Determination 2010/76

Refusal to issue code compliance certificates for an 11-year-old house and extension at 529 Horokiwi Road, Wellington

Figure 1: The original house plus extension

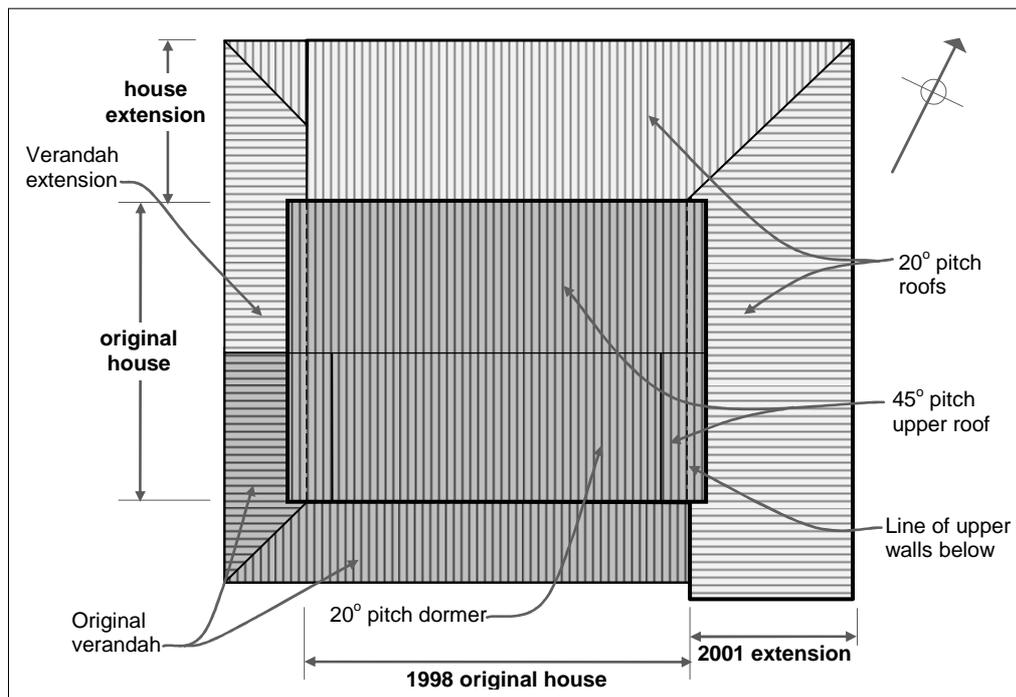
2.1 The building work consists of a detached house and separate garage building situated on an exposed site in a wind zone requiring specific design for the purposes of NZS 3604⁴. Construction is generally conventional light timber frame, with the original house and the extension as shown in Figure 1.

- 2.3.1 The 2001 building work added an extension to the north and east elevations to provide a tandem double garage area, a lounge area, a sunroom and the original verandah extended along the west elevation. The extension has concrete block foundations and a concrete slab. The claddings and windows match those of the original house and the 20° pitch lean-to roof has no eaves or verges.
